THEORY U DISTRICT

DESIGN RECOMMENDATION PACKET #2
AUGUST 21, 2020
#3034632-LU 4731 15TH AVE NE

VIEW AT ENTRY STOOP (UPDATED)

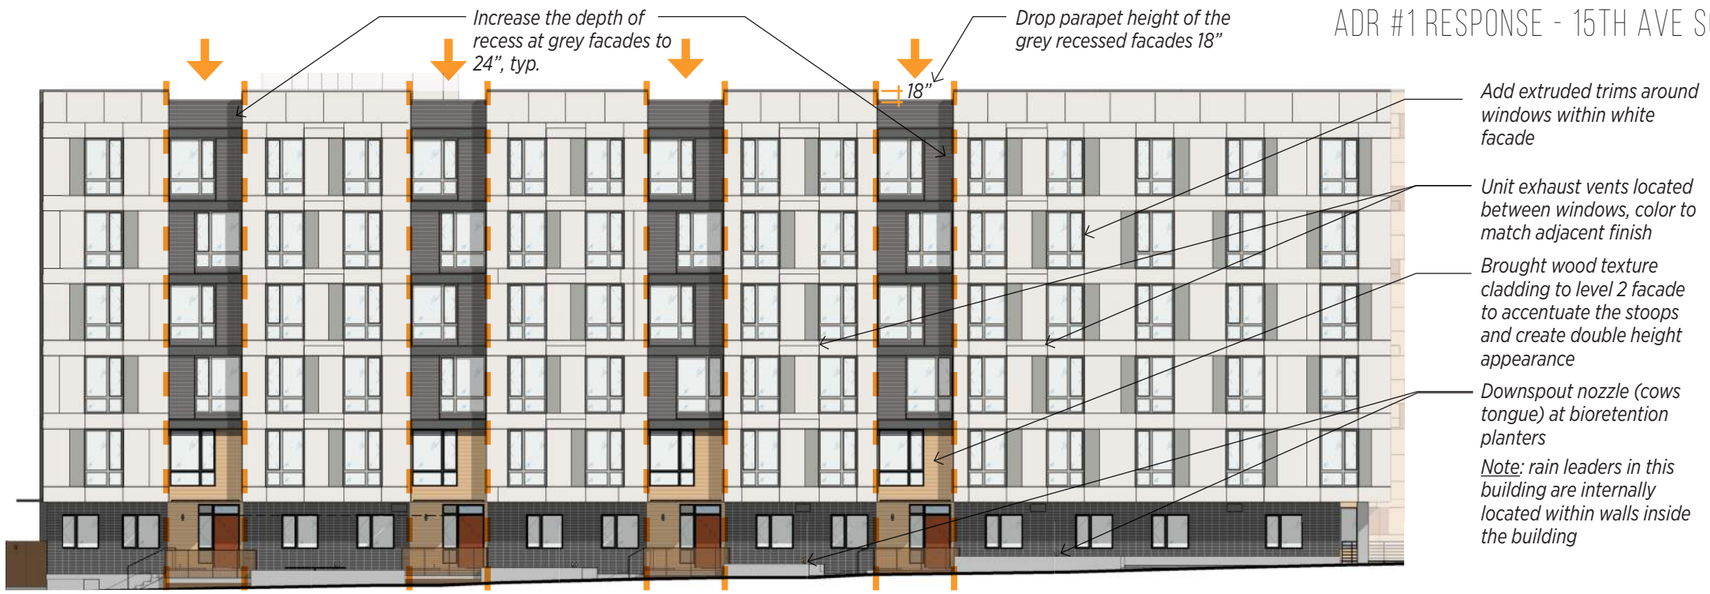
Staff echoes the Board's support for the stoops and residential character along the street-level. However, the design response to the Board's guidance regarding legibility and balancing street-level interaction with privacy concerns need to be further developed. Include the following studies with the next submittal:

i. Adding canopies at the street level residential units
ii. Adding raised planters placed in front of residential windows
iii. Further demonstrate how the planting palette will survive long-term under the overhang condition.
iv. Use black framed windows at street level

Following the staffs recommendation, steel canopies have been added above each stoop/patio at street level, to improve the legibility of the stoops. In addition, the windows at street level within the brick facade will include black framed windows.

The majority of the planting areas along this facade are bioretention planters. As such, they are frequently wet with rainfall collected from the roof. We propose raising the bioretention planter walls to an average of 12" (previously 6") high along the edge of the sidewalk, in order to discourage anyone from walking into them. This, coupled with the approximately 12" drop to the top of soil within the bioretention planters, provides a good physical separation from the unit windows and improves safety and privacy for street level units. 'Building up' these planters with taller walls would make the sidewalk feel narrower, and could also invite unwanted use in front of the units, both of which we want to avoid. Outdoor seating has been accommodated in the entry court area to the north.

The plants under the overhang will receive watering year-round in two ways: runoff from the roof as part of the bioretention system and automatic irrigation. The plants chosen for these planters are appropriate for this specific micro-climate and moisture condition.

A WINDOW JAMB DETAIL w/ EXTRUDED TRIM FLASHING

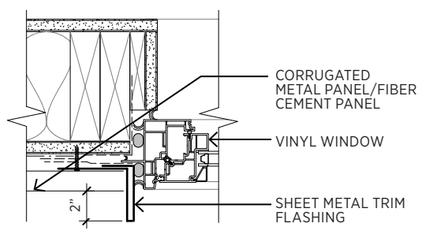
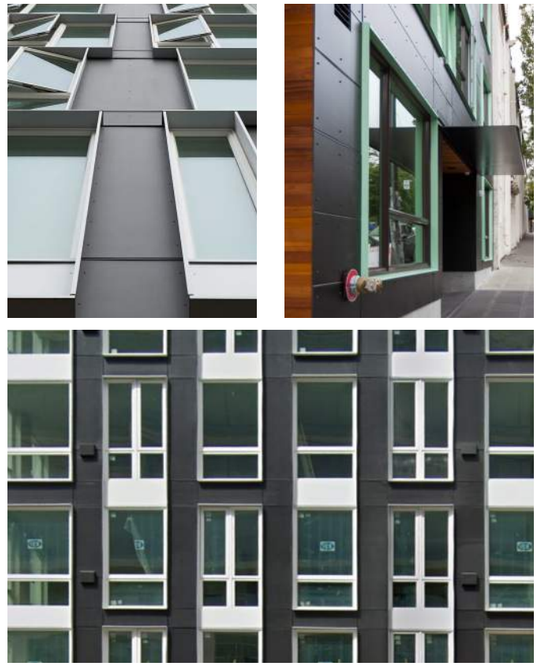
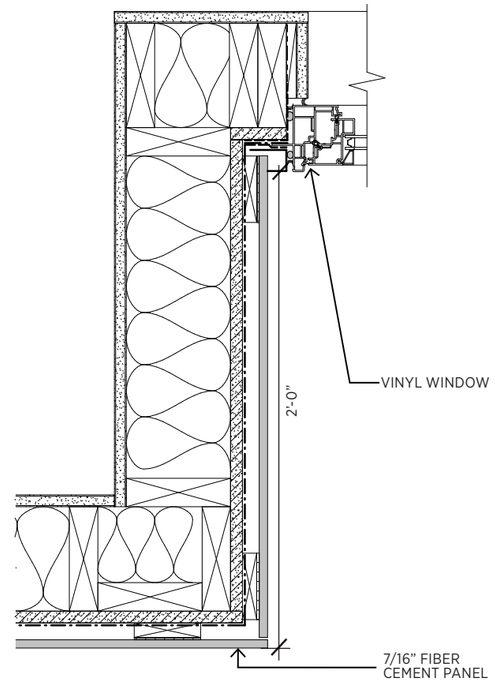
Staff remains concerned with the height, bulk, and scale of the south massing volume. Greater recess between the white plane and dark grey is needed to mitigate the long flat facade. Specifically, a 1' recess is not sufficient to mitigate the bulk and scale of this long facade. Include the following studies with the next submittal:

i. Drop the parapet height of the white or grey facades
ii. Recess the windows within the white areas
iii. Increase the recess to min 30" depth
iv. Lift the bays up for the four southern bays
v. Include vents and down spouts that are integrated into the design

To improve facade articulation, the design team is proposing adding 2" extruded projected trims around windows on the white facade to provide sense of depth and create shadow lines. Several precedence photos have been included in this packet showing successful application of this strategy. See following page.

To improve facade articulation, the design team is proposing adding 2" extruded projected trims around windows on the white facade to provide sense of depth and interest by creat shadow lines. Several precedence photos are included in this packet showing successful application of this strategy.

WEST ELEVATION (UPDATED)

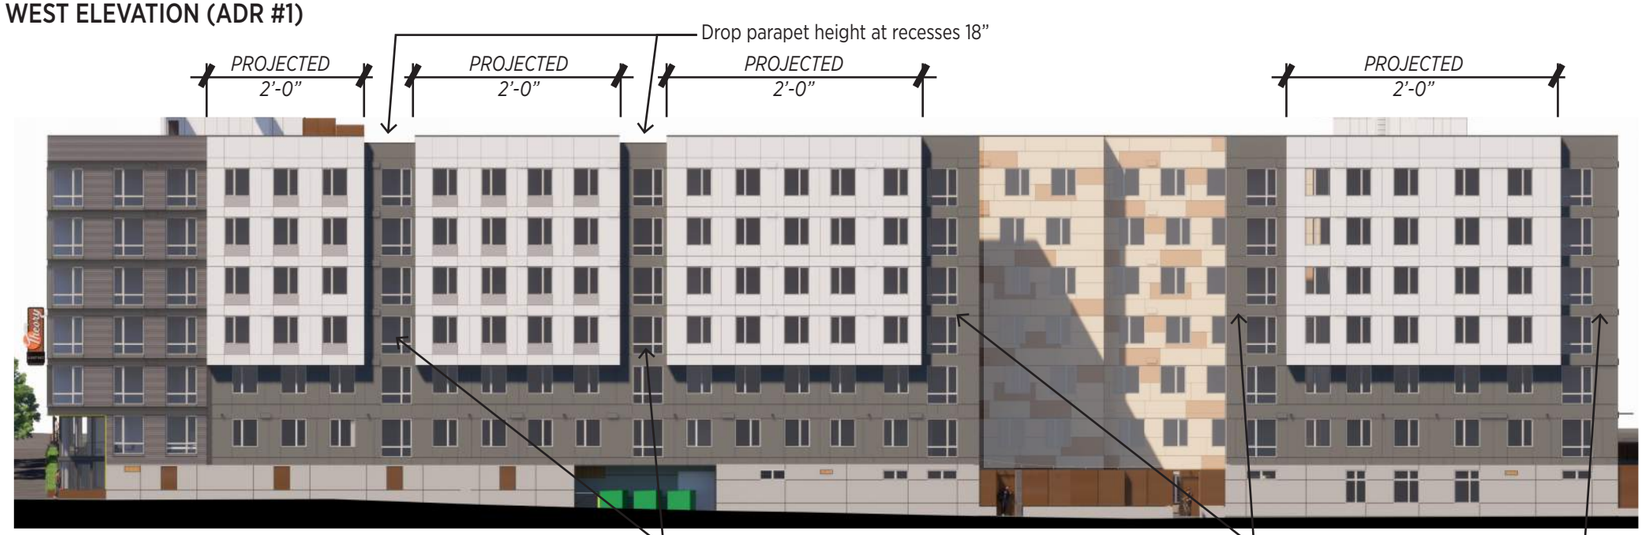
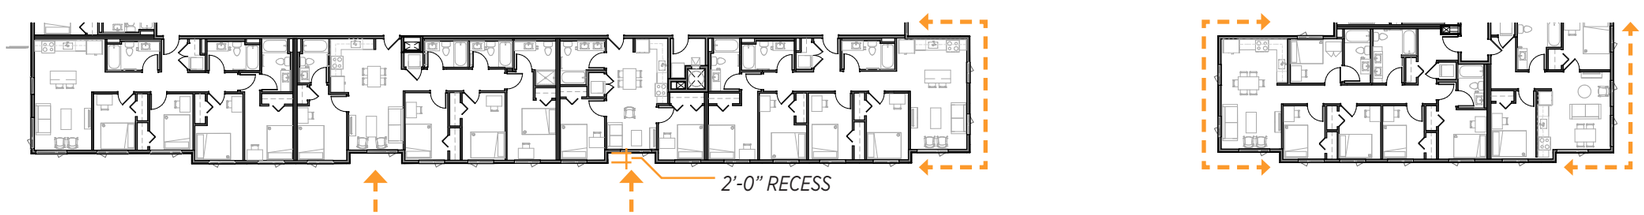
As previously commented by Staff, the alley requires further relief beyond one small recess. With the next submittal staff expects to see the alley design resolved in a manner more consistent with the street facing facades. Specifically, resolve the alley to more clearly relate to the established architectural language applied to the south massing structure.

In response to staff's comment, the design team has added several strategically placed 24" deep recesses along the alley facade to match the recess on the south massing along 15th Ave. The parapet height of the recesses is also dropped 18" similar to the southwest facade to further improve the facade modulation. These recesses are aligned with level 1 and 2 exterior walls below and are carried around into the courtyard and south facades.

PARTIAL PLAN - MAIN ENTRY (UPDATED)

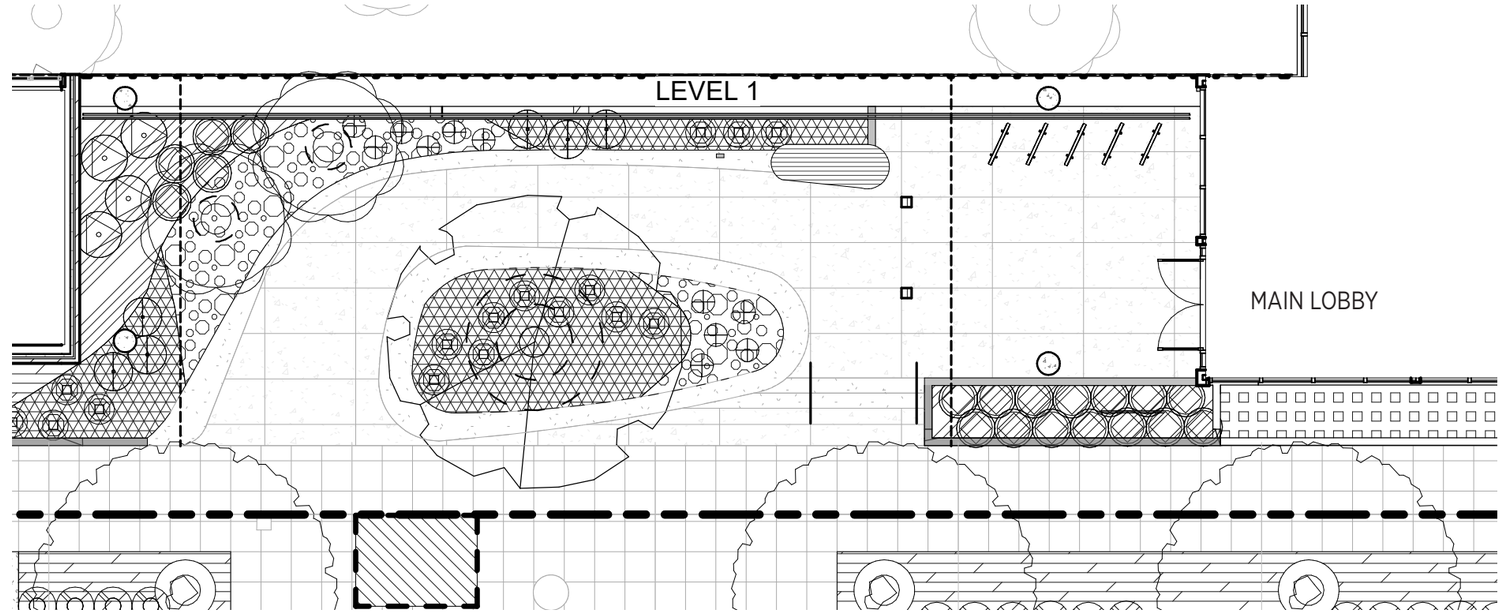
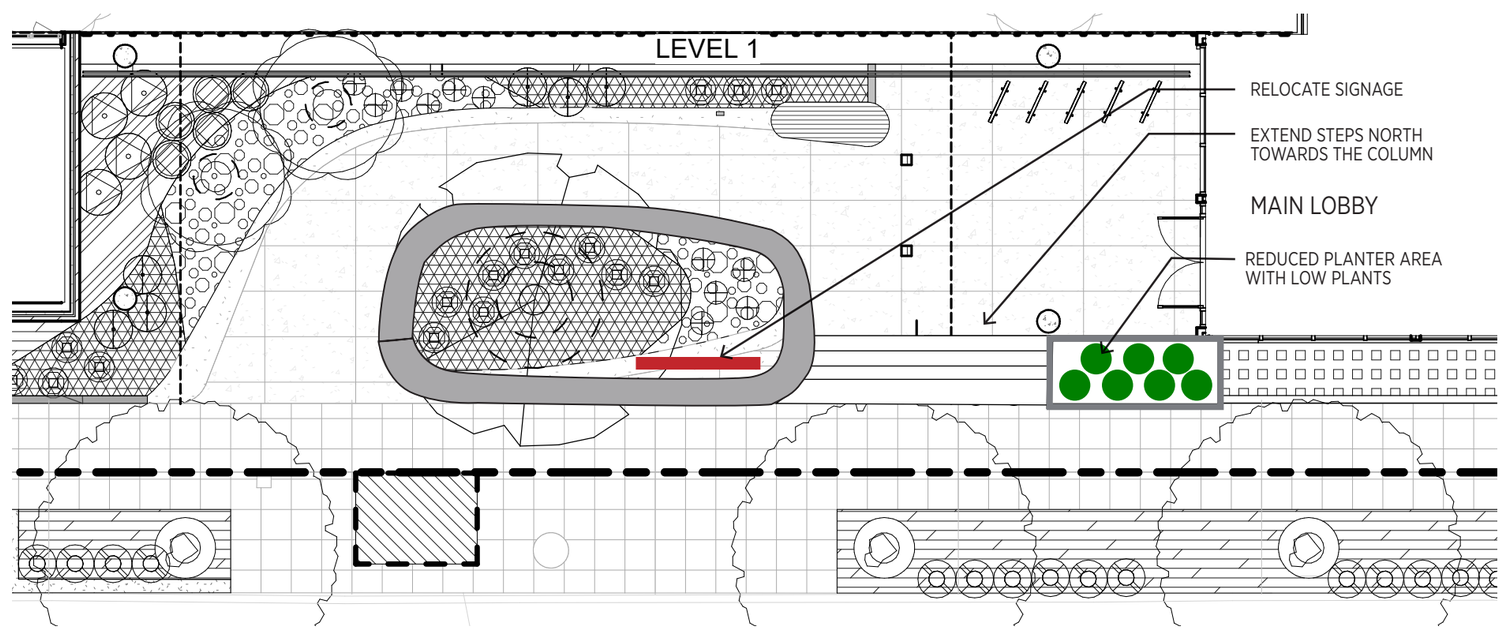
Staff is concerned with legibility of the main entry due to the combination of entry location (pulled away from the street) and further closing off the entry with the seat wall and landscaping. Revise the entry configuration to improve the legibility of the main entry.

To address staffs concern, we propose extending the steps further to the north, reducing the size of planter area next to the main entry door, and relocate the signage in order to improve the visual connection and visibility of the main entry.

There is approximately 22" grade differential between the sidewalk and the finish floor of the lobby. The reduced planter area with low planting can still accommodate the grade transition while allowing better visibility to the entry. Extending the steps to the north to be approximately 14' wide improves visual and physical relationship between sidewalk and the lobby entrance.
